2. AMENDMENT/MODIFICATION NO. 0002	3. EFFECTIVE DATE 9/27/01	4. REQUISITION/PURCHASE REQ. NO.	5. PROJECT NO. <i>(If applicable)</i>
--	-------------------------------------	----------------------------------	---------------------------------------

14. DESCRIPTION OF AMENDMENT/MODIFICATION *(Organized by UCF section headings, including solicitation/contract subject matter where feasible.)*
Sabine-Neches Waterway, Texas, Port Arthur Canal, Junction Area, and Turning Basins in Jefferson County, Texas, Dredging
 (See Attached)

1. The specifications and drawings for Invitation No. DACW64-01-B-0033, Dredging, Port Arthur Canal, Junction Area, and Turning Basins in Jefferson County, Texas, Sabine-Neches Waterway, Texas, advertised 4 September 2001, and for which bids are rescheduled to be opened on 10 October 2001, are hereby modified as follows:

**SABINE-NECHES WATERWAY, TEXAS
PORT ARTHUR CANAL, JUNCTION AREA,
AND TURNING BASINS IN JEFFERSON
COUNTY, TEXAS, DREDGING**

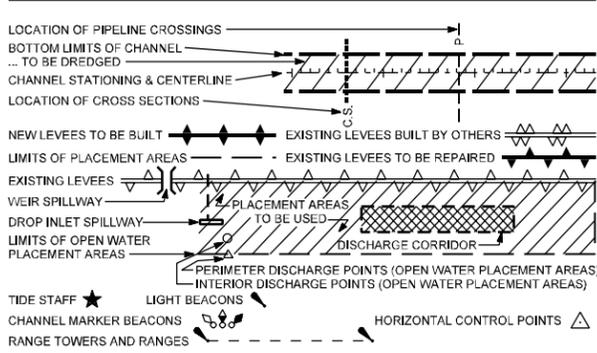
AM.0002	9-25-01	RELOCATED DISCHARGE CORRIDOR & REMOVED NOTE	G.T.
REVISION	DATE	DESCRIPTION	BY
OFFICE OF THE DISTRICT ENGINEER U.S. ARMY ENGINEER DISTRICT, GALVESTON CORPS OF ENGINEERS GALVESTON, TEXAS			
DRAWN BY: V.J.P.		SABINE-NECHES WATERWAY, TEXAS DREDGING PORT ARTHUR CANAL JUNCTION AREA AND TURNING BASINS	
CHECKED BY: R.W. / R.F.			
SUBMITTED BY: H. SUTCLIFFE, P.E., AREA ENGINEER		PLAN PLACEMENT AREA NO. 8	
APPROVAL RECOMMENDED: D. B. CAMPBELL, P.E., CHIEF, ENGINEERING BRANCH	APPROVED: HARRY G. KOHLER, P.E., CHIEF, ENGINEERING AND CONSTRUCTION DIVISION	DATE: AUGUST 2001	
Prepared under the direction of Leonard D. Waterworth, Col., C.E., District Engineer		SCALE: AS SHOWN	DRAWING NUMBER
		SHEET 14 OF 22	FILE NO. SN 103-348

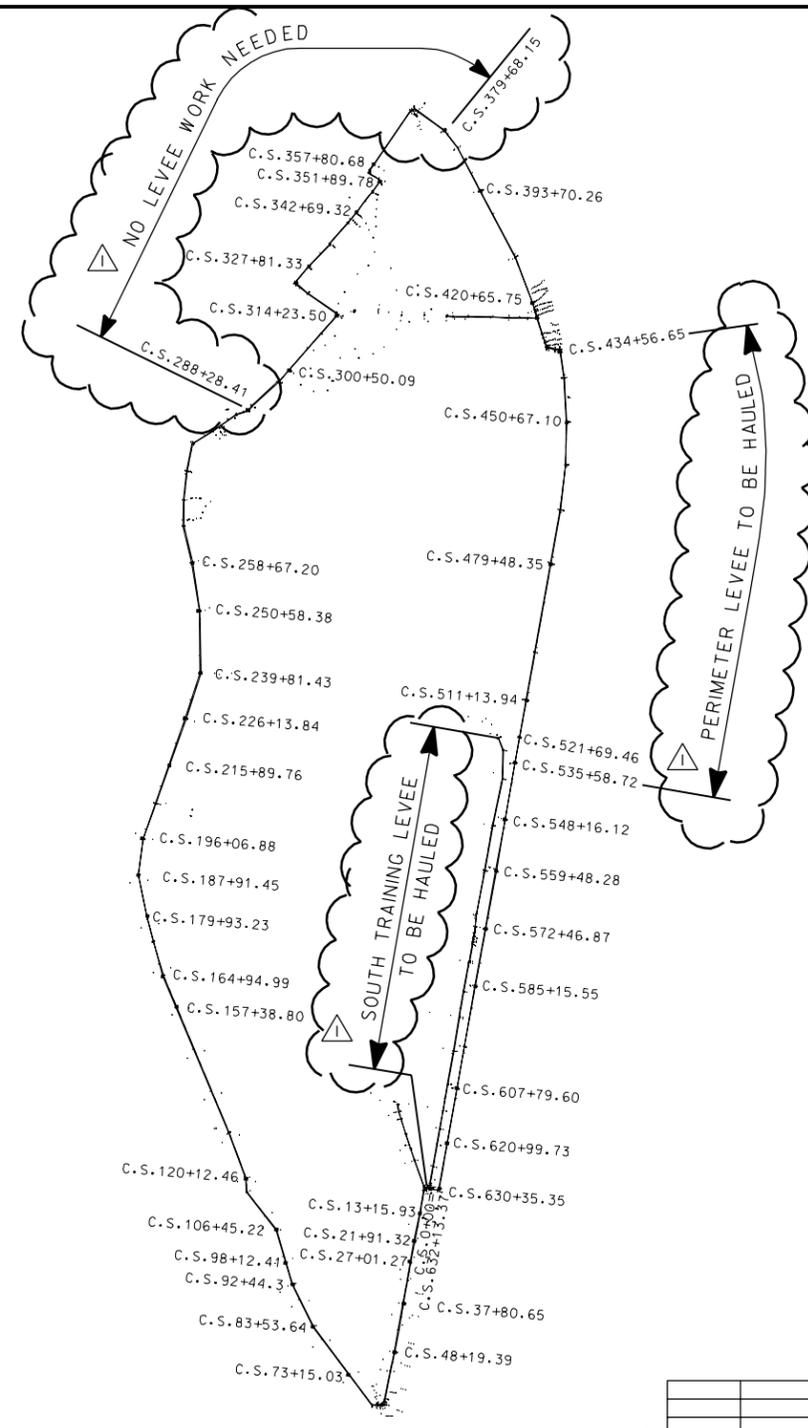
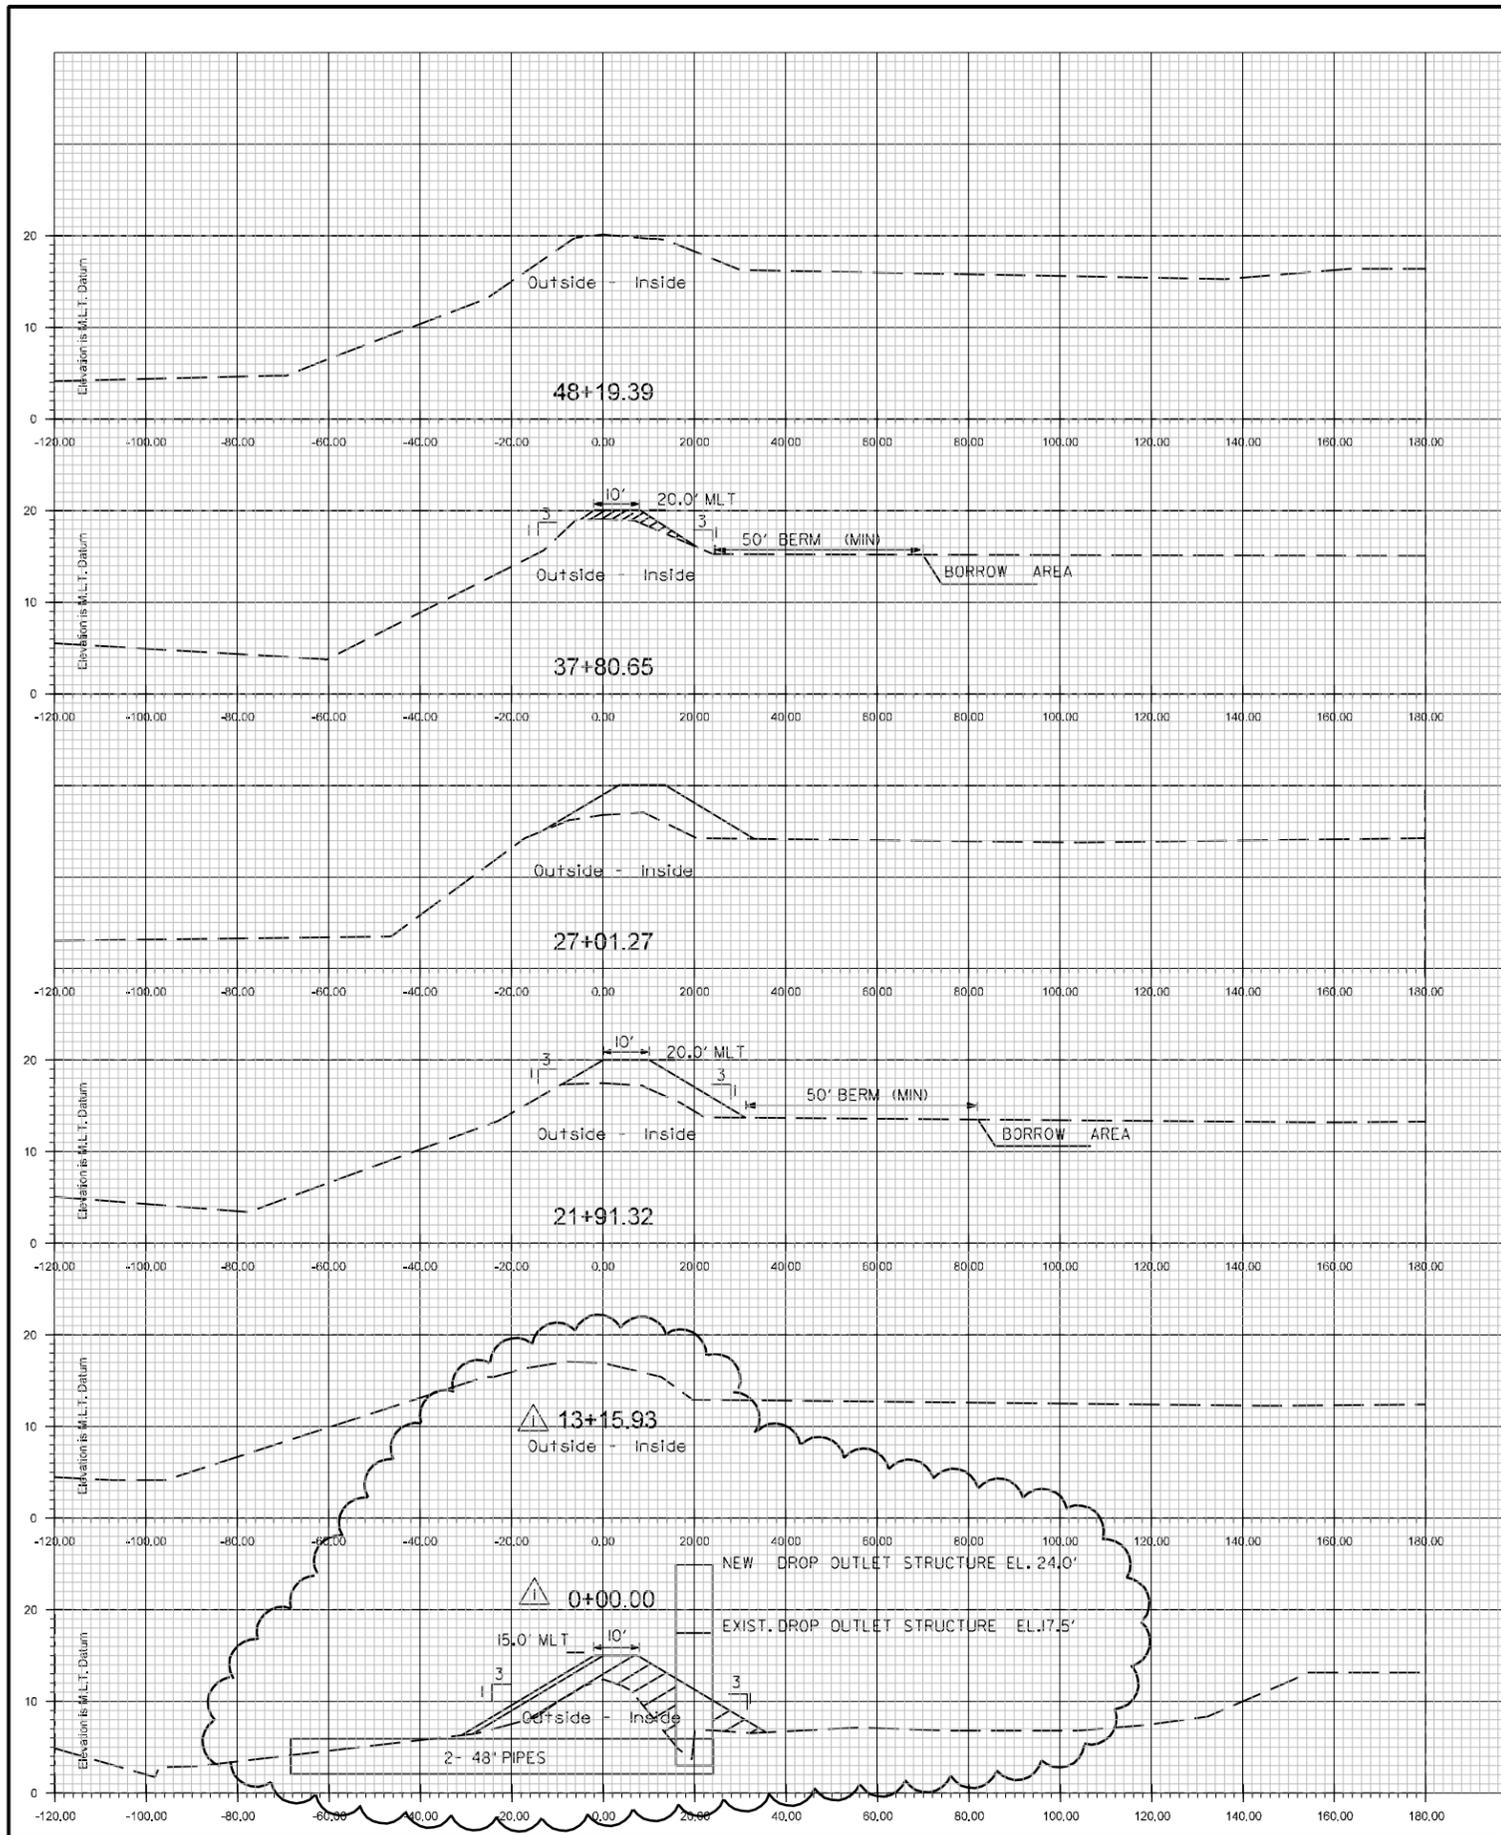
AM.0002	9-25-01	REVISED LEVEE ELEVATIONS & ADDED NOTES	G.T.
REVISION	DATE	DESCRIPTION	BY
OFFICE OF THE DISTRICT ENGINEER U.S. ARMY ENGINEER DISTRICT, GALVESTON CORPS OF ENGINEERS GALVESTON, TEXAS			
DRAWN BY: * V.J.P.		SABINE-NECHES WATERWAY, TEXAS DREDGING PORT ARTHUR CANAL JUNCTION AREA AND TURNING BASINS	
CHECKED BY: * R.W. / R.F.			
SUBMITTED BY: * H. SUTCLIFFE, P.E. AREA ENGINEER		PLAN PLACEMENT AREA NO.8 STA.0+00 TO STA.48+19.39	
APPROVAL RECOMMENDED: * D. B. CAMPBELL, P.E. CHIEF, ENGINEERING BRANCH		APPROVED: * HARRY G. KOHLER, P.E. CHIEF, ENGINEERING AND CONSTRUCTION DIVISION	DATE: _ AUGUST 2001 _
*AS REQUIRED BY ENGINEER REGULATION NO. 10-1-85(2)		SCALE: AS SHOWN	DRAWING NUMBER SHEET 15 OF 22 FILE NO. SN 103-348
Prepared under the direction of Leonard D. Waterworth, Col., C.E., District Engineer

**CROSS SECTIONS
 PLACEMENT AREA NO.8
 STA.73+15.03 TO STA.187+91.45**

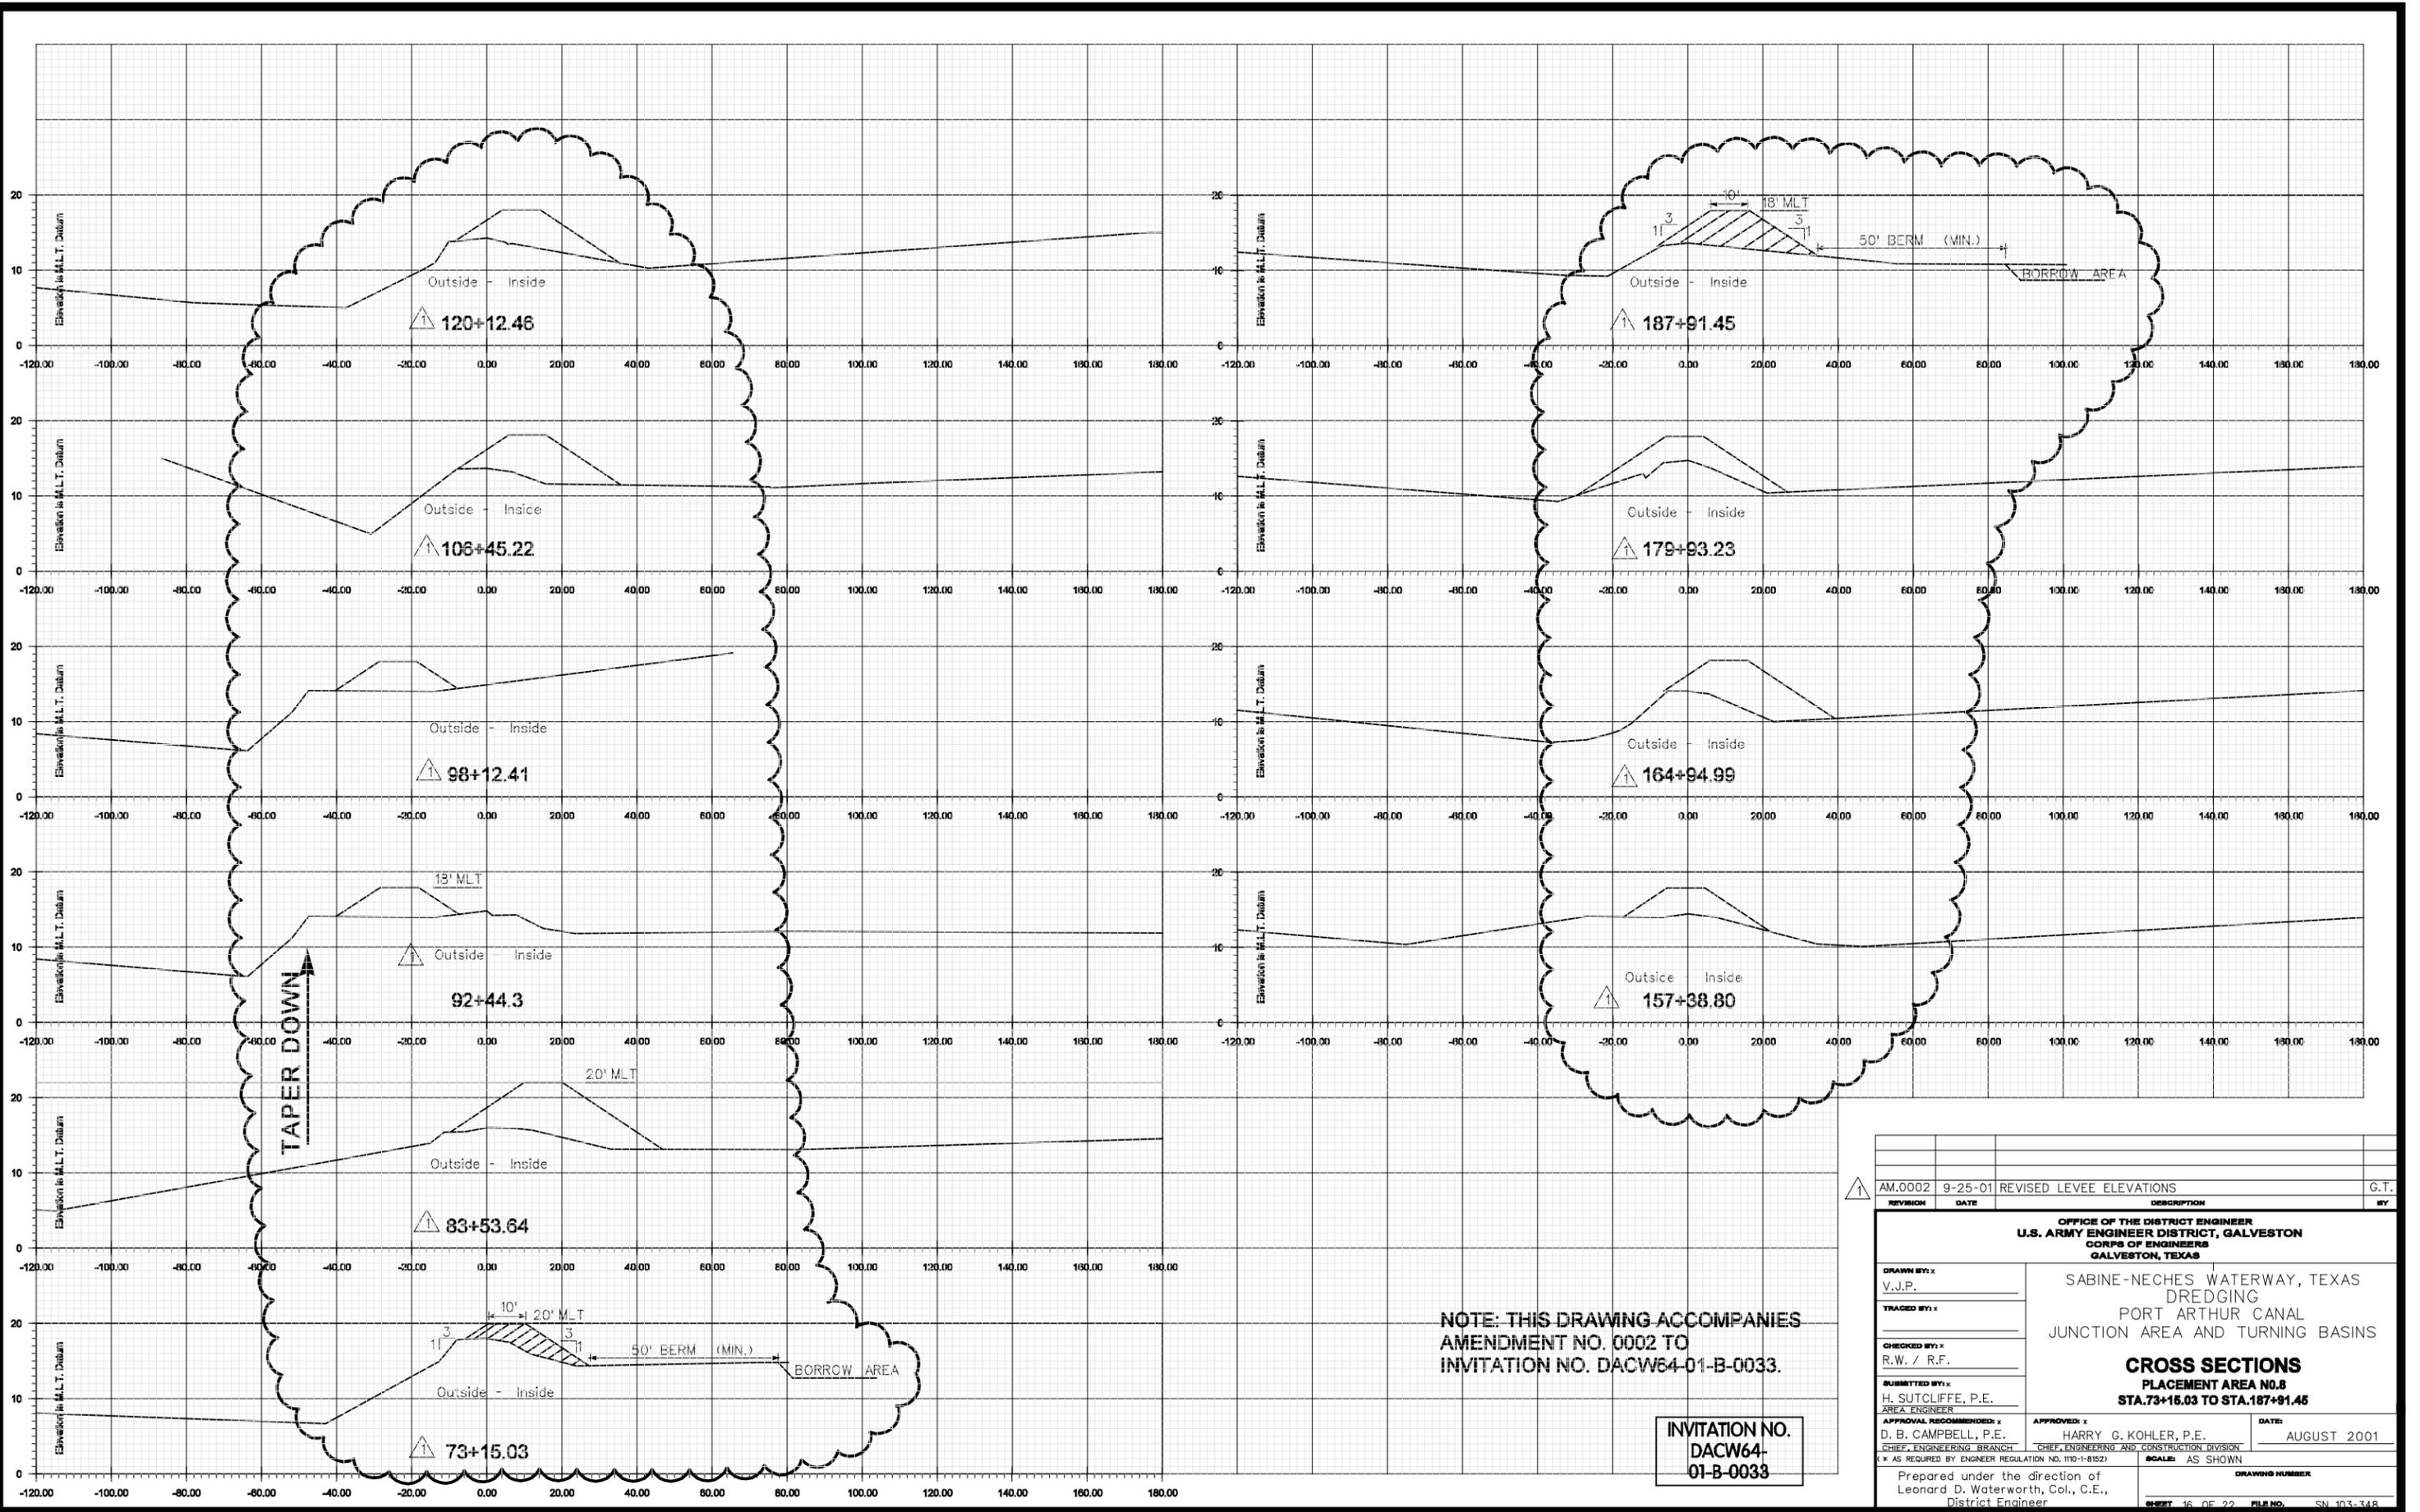
REVISION	DATE	DESCRIPTION	BY
AM.0002	9-25-01	REVISED LEVEL ELEVATIONS	G.T.
